Functional Specification, CCD-1006A  
Data Set and Interface Connections  
Customer Preparation for TermiNet Printers, DCP-1110

### SERVICE ADVICES

Service Advice Index  
Service Advices

Figure 1 Line Feed Clutch & Jackshaft Combinations

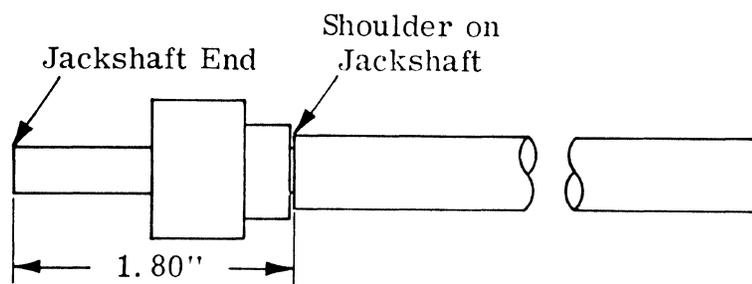
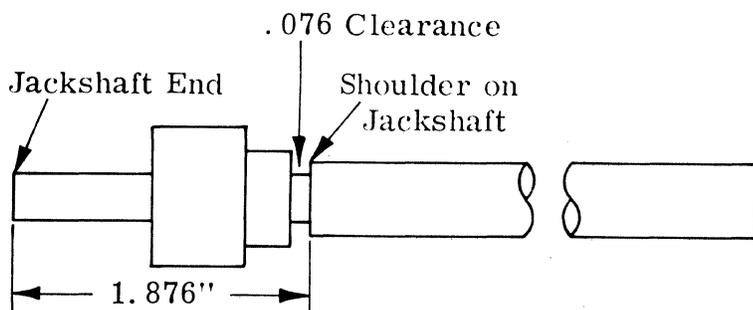
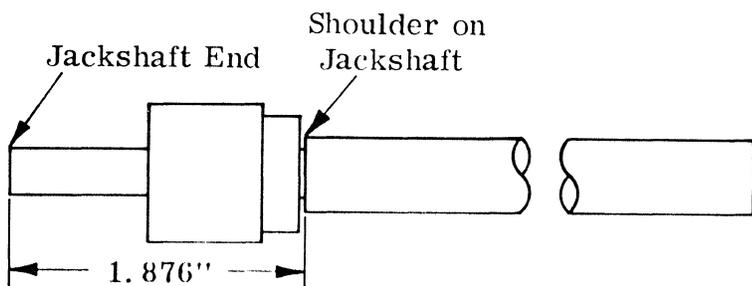
If a "B" model jackshaft is used with an "A" model clutch (Part No. 44C414046-G01) a .076" clearance (See figure 1) must be provided between the shoulder on the jackshaft and the clutch. The "A" model jackshaft (Part No. 44B412057-001) and "B" model clutch are incompatible. Figure 1 shows possible line feed clutch and jackshaft combinations.

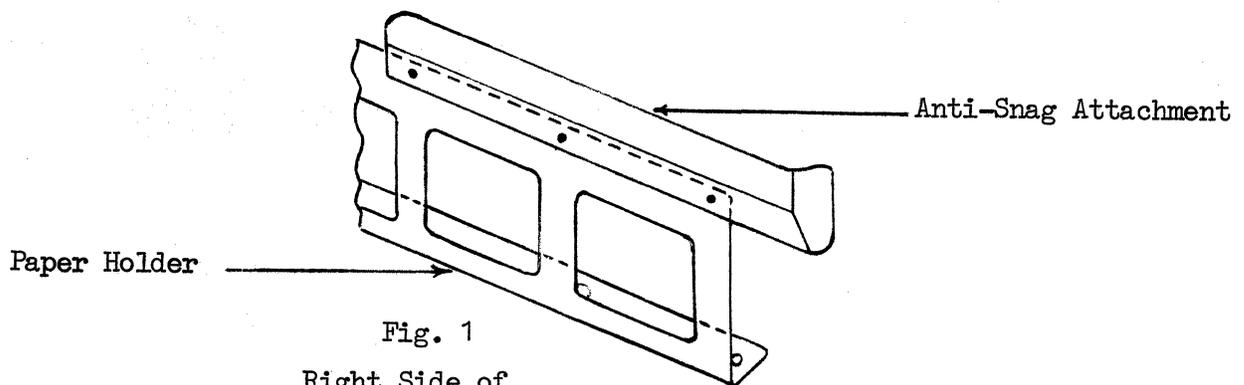
The purpose of the new paper holder (see Figure below) is to prevent moving print fingers from snagging paper should it loop away from or not be snug against the platen.

The procedure for replacing the old style paper holder with the new one takes approximately ten minutes and is as follows:

1. With power off of the machine, raise the top cover.
2. Remove the platen and paper pan.
3. Remove the smaller rollers (if friction feed) toward front of machine.
4. Remove the old paper holder as follows:

Figure 2 - Pulley Alignment

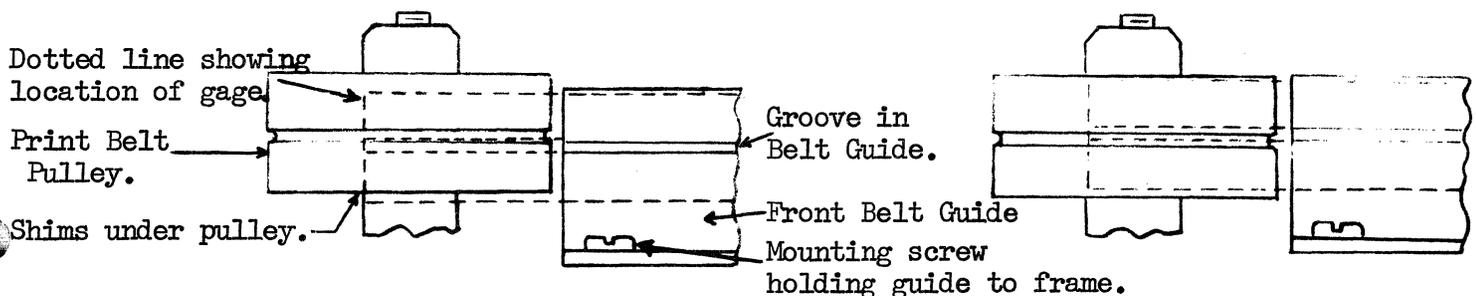
PULLEY TOO HIGH - REMOVE SHIMS TO CORRECT PROBLEM

PULLEY TOO LOW - ADD SHIMS TO CORRECT PROBLEM

1. Remove the print belt (refer to GEH-2185, pages 5-20).
2. Insert the tongue on the gage into the groove on one end of the front belt guide.
3. Holding the gage firmly against the front belt guide, check to see if the tongue on the gage will go into the groove on the pulley. If not, raise or lower the pulley as necessary for correct alignment by adding or removing pulley shims (see figure 2).
4. When the correct vertical alignment on one pulley has been verified, check, and align as necessary, the other pulley by repeating step 3.
5. Replace the print belt. Make sure the .003" - .008" clearance is maintained between the print belt and the rear belt guide.
6. Check for drag by rotating the print belt by hand.

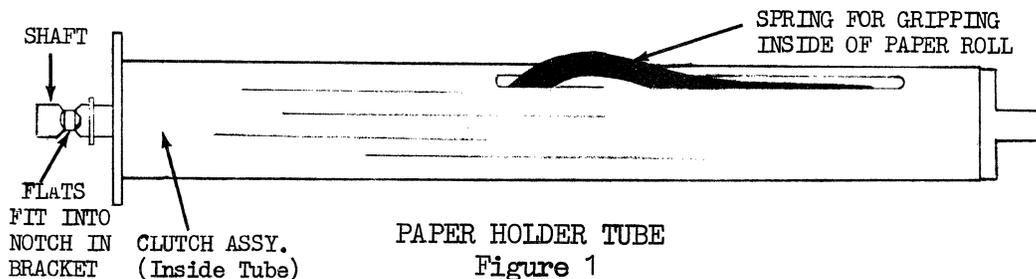
A new style paper holder consisting of aluminum tube (44A410482-G01), two brackets (44A410483-001), and adjusting stud (44A410484-001) has been introduced on all Terminet 300 Printers manufactured since fiscal week thirty. (The first four numbers in the Printer's serial number define the year and fiscal week of manufacture).

The new paper holder may be installed on any Model "B" Printer in situations where paper skewing, improper paper tracking or feeding is being experienced. To make the conversion, the two new brackets and adjusting stud are required in addition to the paper tube.

Figure 1. Senseline Assembly

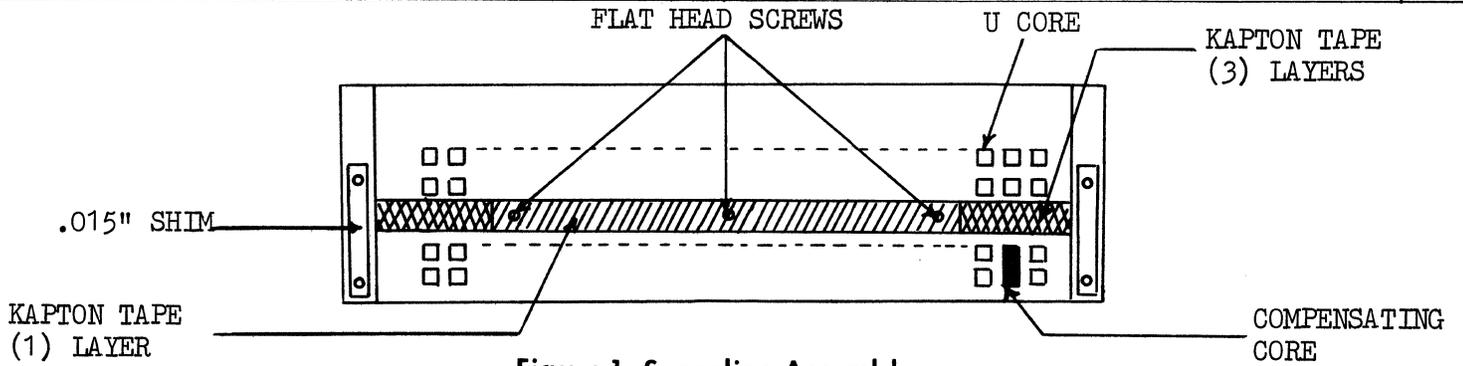
The keyboard senseline modification covered by this Service Advice should be made to only those B Model Terminet 300 Printers having keyboard problems such as (a) double print or key wiggle problems from keyboard operation, or (b) U core breakage. These problems have been isolated to the mounting location of the senseline board, and to the compensating core which is located in the front row, second position from the right of the senseline board (see Figures 1 and 3).

19. Add 1/2" wide protective tape (see list of recommended tapes below) on the solder side of the senseline printed circuit board. Apply one layer of tape between the two rows of U cores, and two additional layers on either end of the board over the top of the first layer. Extend the short strips up to the outer flat head screws as illustrated in Figure 1. Tape must be Kapton<sup>2</sup> type, .0025" thick.

Figure 2. Senseline Mounting

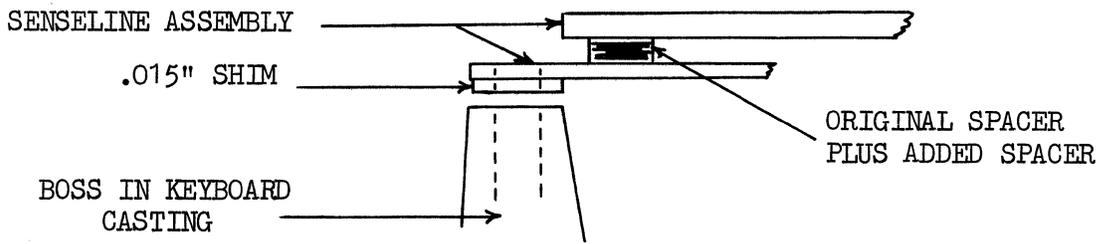
20. Glue the two (2) fishpaper shims to either end of the senseline mounting plate so that the fishpaper will be between the mounting plate and the keyboard casting when the senseline assembly is installed in the keyboard. See Figure 2.

Figure 3. U Core Mounting

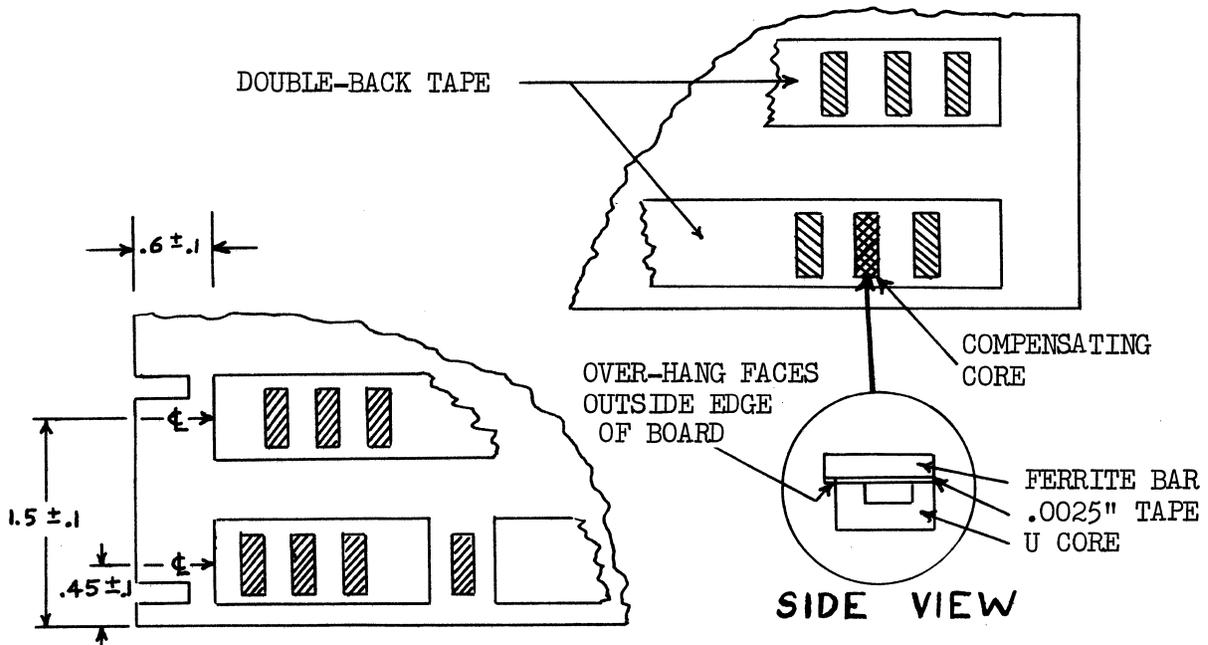
- \*12. Place a small drop of Loctite on each flat of the U core.
- \*13. Place ferrite bar with mylar tape squarely on top of U core (see Figure 3) keeping inside edges flush. (Caution: Loctite sets within 10 seconds).

### VTFF MOTHERBOARD CONNECTOR (J9)

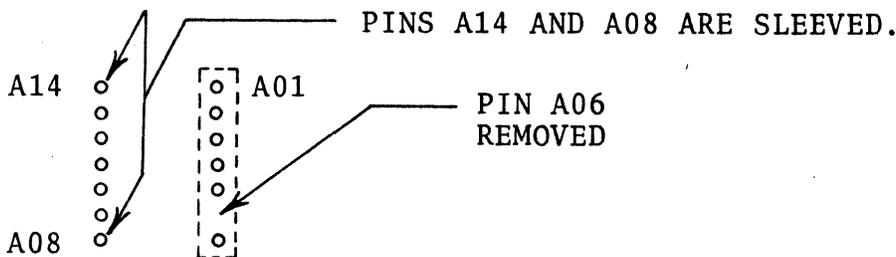
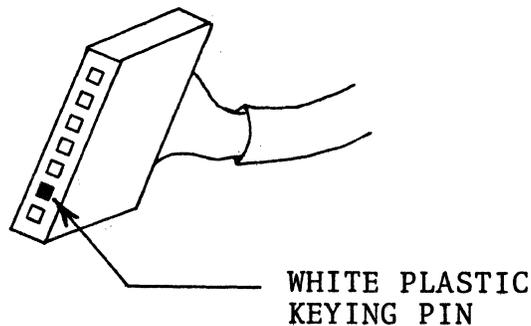
A change has been made on Terminet 300 and Terminet 1200 Mother Boards. Pin 6 on the VTFF connector has been removed. This change, effective 7/31/73, has been made to ease orientation and connection of the VTFF assembly plug.

The plug on all new VTFF assemblies is built so it will key on this re-designed Mother Board connector.

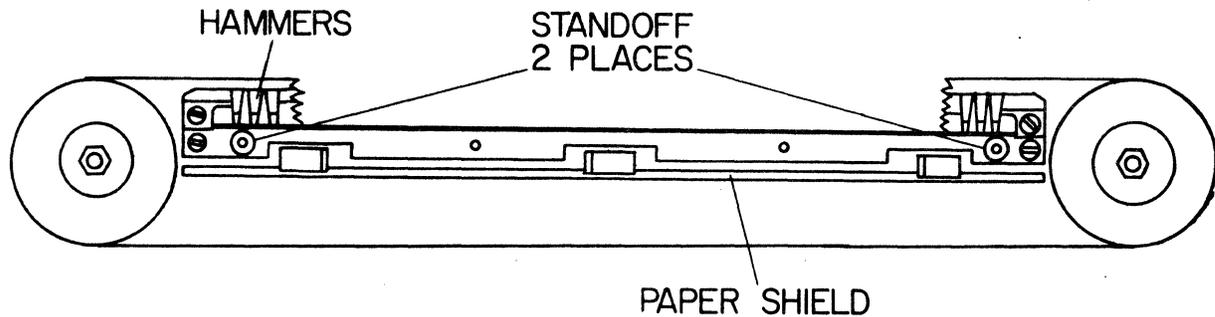
A few Terminet 300 Printer Tractor models have been shipped from the plant with two standoffs missing. These standoffs mount on top of the hammer-bank and hold the paper shield off of the Platen. Without these standoffs, proper paper feeding cannot occur.

The drawing below shows the standoff locations. Their part number is 44A410778-001 and they are mounted with 2-56 x .25" Allen head screws (N170P5004C).

If you encounter Printers in the field without these standoffs, they should be added. The longer screws, listed above, must be used when mounting the standoffs. The screws now used are too short.

#### NEW XFMR PLUG (P10 Female Plug)

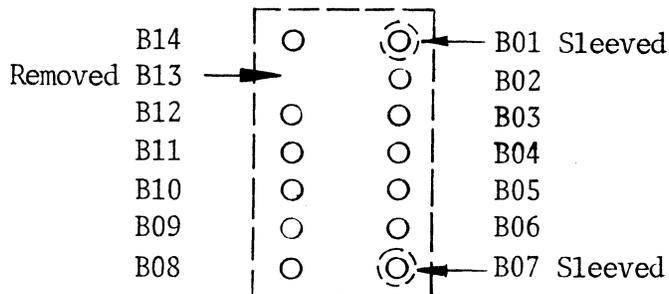
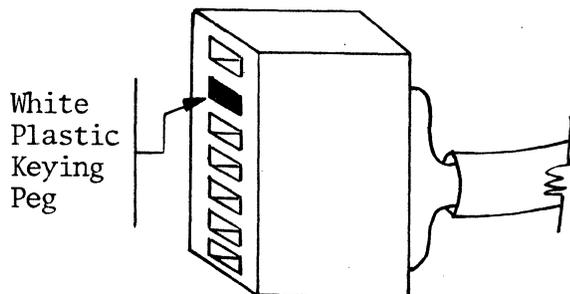
This change insures that the plug and the connector will only be mated properly and only with each other.

Should you have to replace the transformer in a Printer, the replacement part will have this new keyed plug. You will have to modify your Mother Board POWC connector to accept this keyed plug. Do this by removing pin B13 from J10. Do not remove the keying peg from the XFMR plug slot, however, for this would defeat the keying effect.

Reader Drawer Top View (Not to Scale) and Connection Diagram

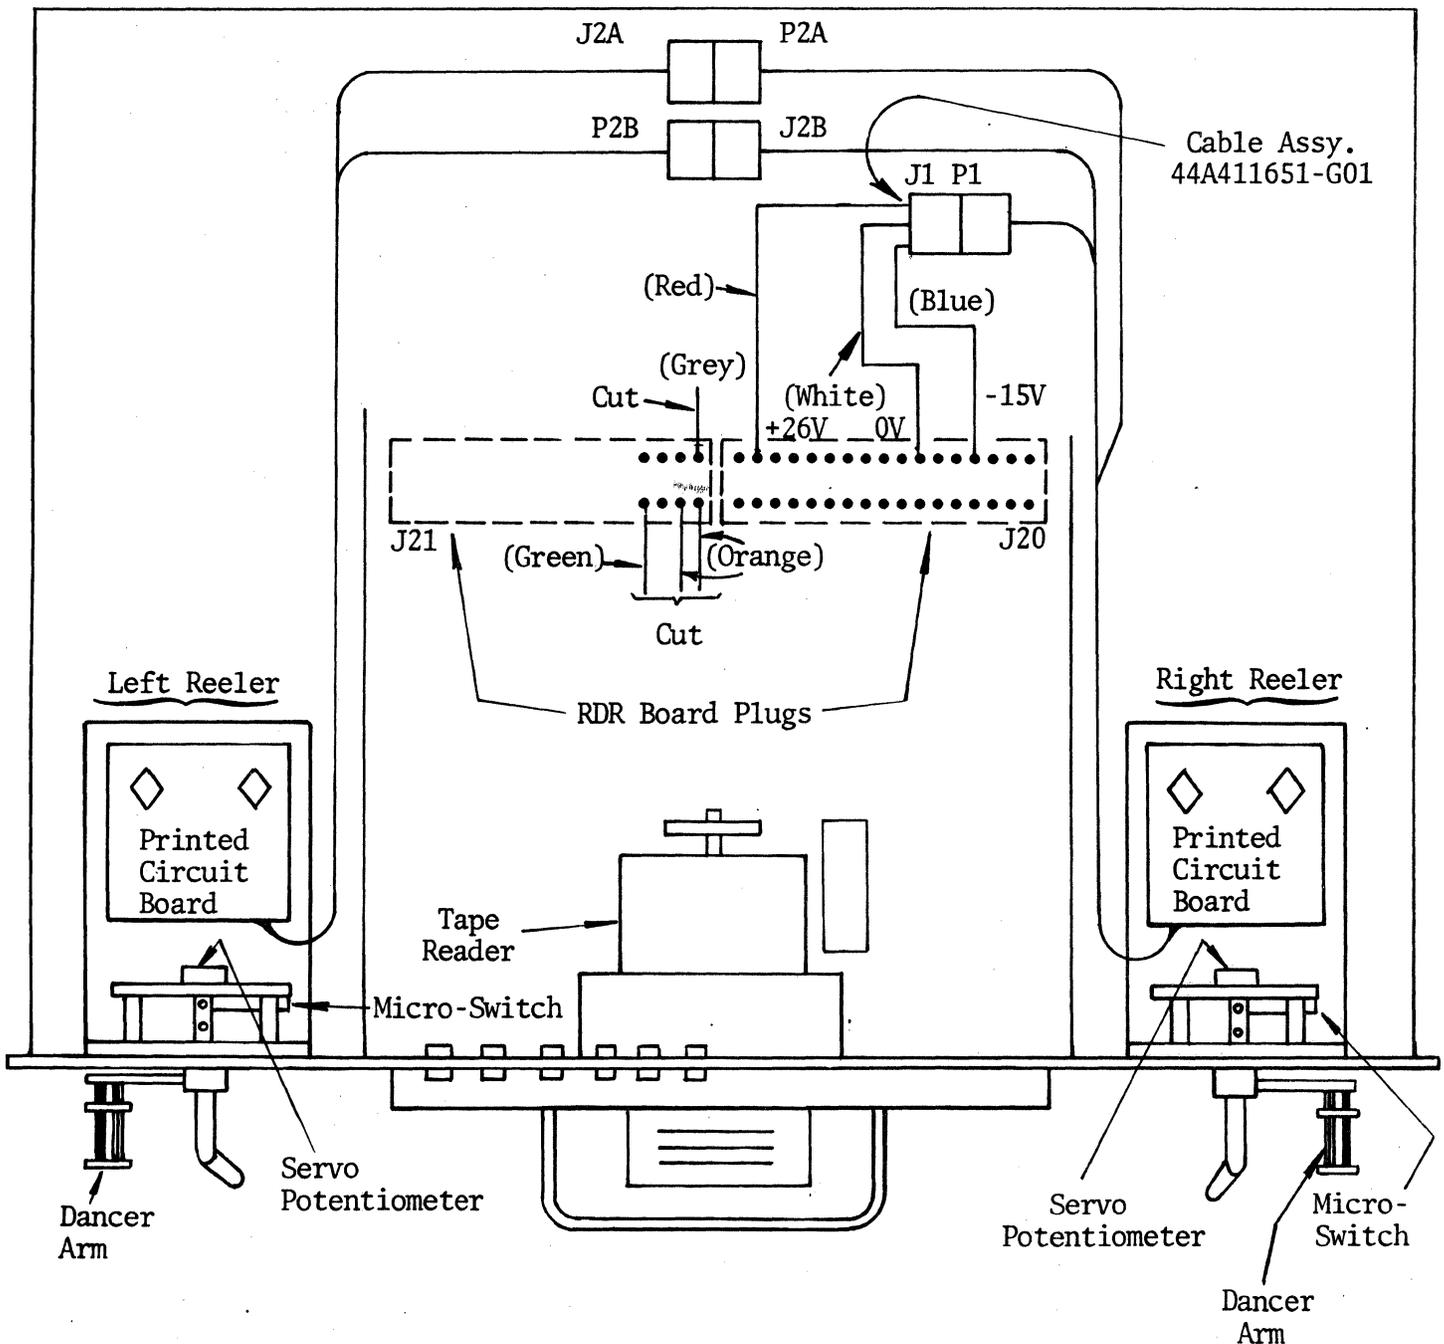
4. Remove the AC Reeler cable harness, including the connections to J21. The connections to J21 (two orange wires, one green wire, and one grey wire--See Figure 1) may be cut with diagonal cutters and taped up. Be careful not to cut any of the wires in the cable going to the Tape Reader.

11. Connect P2A on the Right DC Reeler to J2A in the Left Reeler, P2B on the Left Reeler to J2B on the Right Reeler, and P1 on the Right Reeler to J1 on the Cable Assembly, 44A411651-G01 as shown in Figure 1.

12. Referring to Figure 1, cut the 26V, 0V, and -15V leads coming out of RDR board connector J20 approximately 1 1/2" from the connector and strip approximately 1/2" of insulation from both ends of the cut wires.

13. Using the three wire nuts, 44A319837-003, splice the leads of cable assembly, 44A411651-G01 to the leads cut and stripped in Step 12 as shown in Figure 1.

### LOCATION INFORMATION FOR DRILLING TAPE GUIDE MOUNTING HOLES

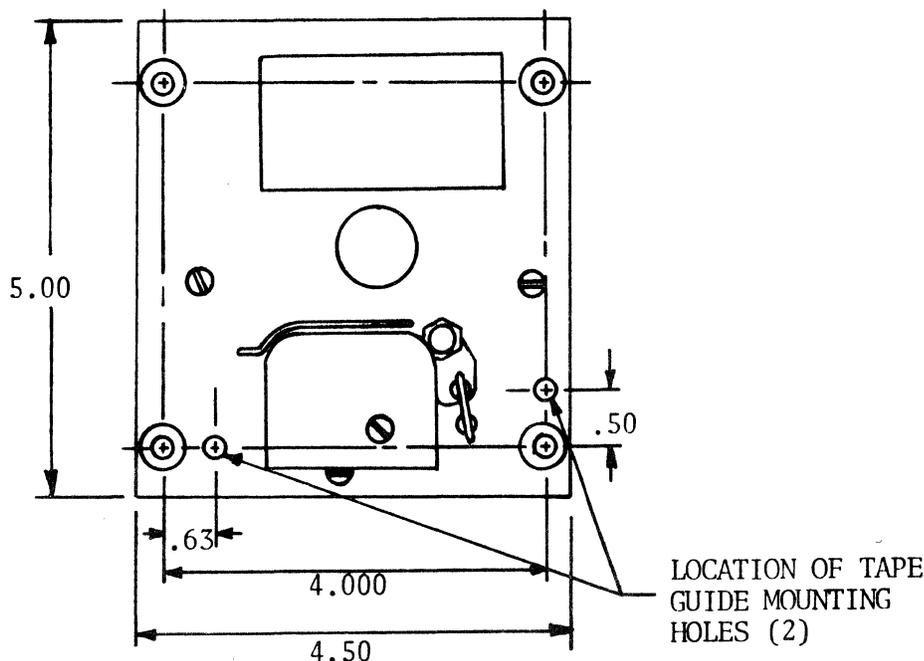
A few of the paper tape readers, 44A417823-002, available as replacement parts may not have the two small holes available in the front mounting plate for mounting the tape guides associated with the reelers option. If it is necessary to use a Reader without these holes as a replacement for a reader in a Reeler drawer, the holes should be drilled at the locations shown in Figure 1 of this Service Advice. Use either a No. 6 or 13/64" twist drill. These holes need not be drilled on Readers to be used on Pedestal ASR's or on desks that do not have Reelers.

Before drilling holes in the Reader mounting plate, cover the Reader head, lamp, and sprocket wheel with a cloth to prevent damage to these parts from chips or a broken drill. The mounting plate should be firmly clamped in a vise during the drilling operation to prevent shock and vibration damage to the Reader. Make sure the Reader lens, photocell cover, tape guide, and terminal board are free of chips and dirt before mounting the Reader in the drawer.
